Access Compliance Report Public Rights-of-Way (Curb Ramps)

Main Street: N/A Cross Street: ANTONIO_PKWY Location: S

ADA ID: RPRK211122120014 Ramp Type: Type 1 - Perpendicular Diagonal Initial Pass/Fail: Fail Overall Compliance: No Severity Score: 15

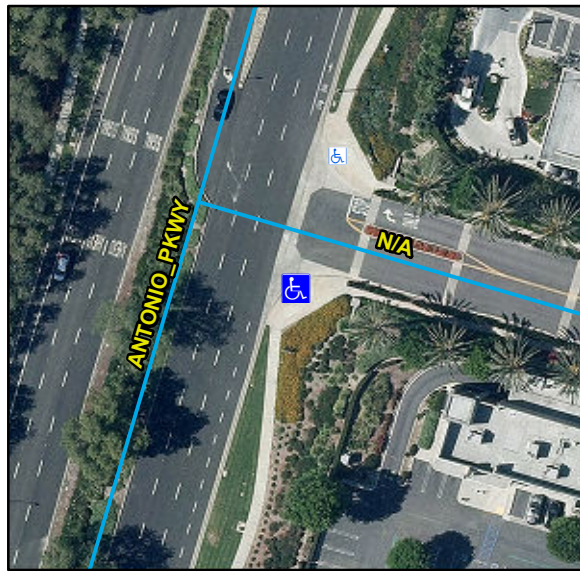
R304.2.2, R204.3, R304.5.3, STD 1115

Remove & Replace Curb Ramp With Two New Directional Ramps or Equivalent.
